OICA response to China's low energy content requirement proposal

Present Chinese proposal

IEC 60479-2 ("Biegelmeier curves")

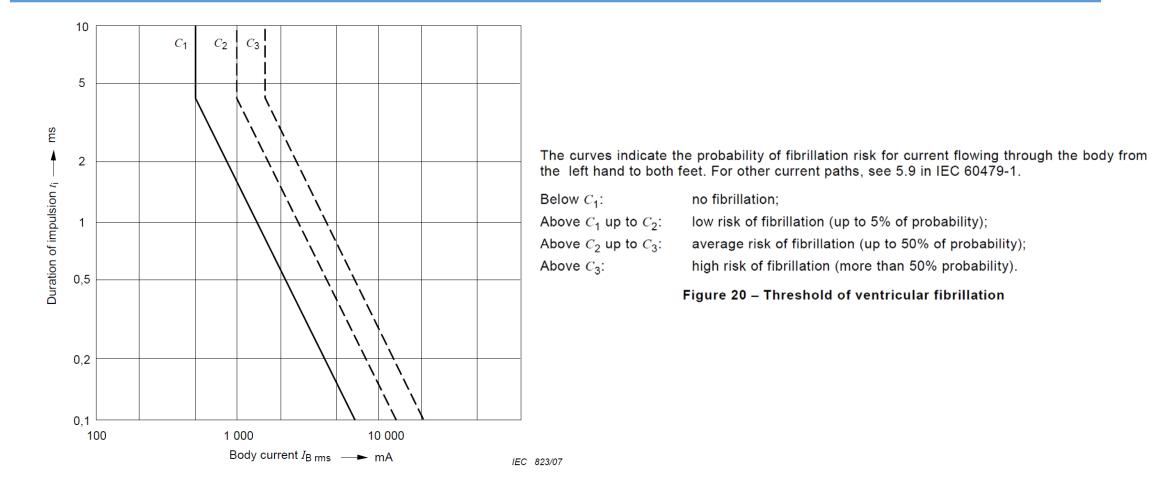
Do not use 0.2 J from ISO 6469-3, but use values from SAE 1772-2017. SAE values are based on IEC 60479/2 and are scientifically based. See next slides.

Rationale for IEC 60479-2

SAE J1772-2017 (maximum capacitance for vehicle and charging column)

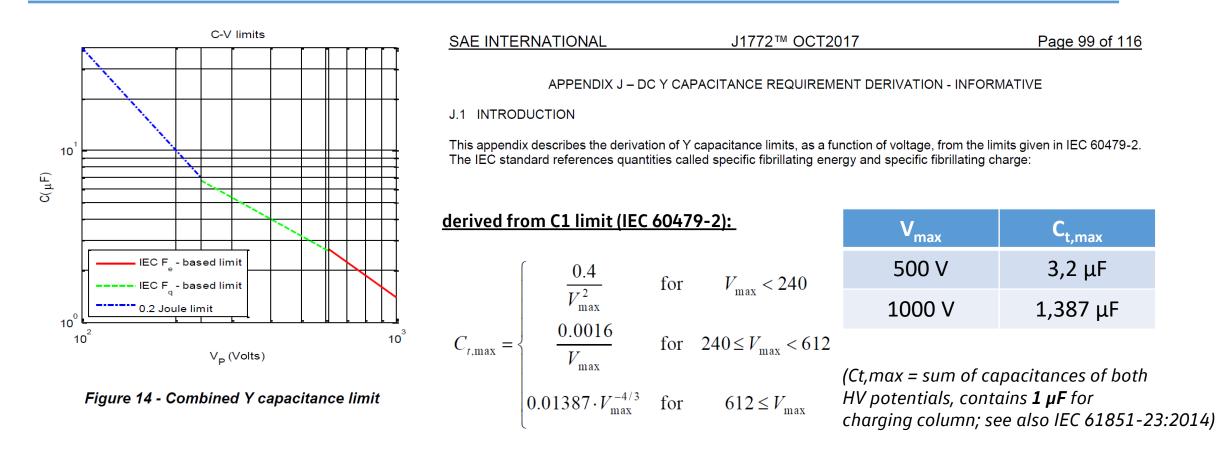
Correct derivation of maximum capacitance

Please note: detailled derivation of formulae and figure can be found in SAE J 1772-2017, Appendix J.
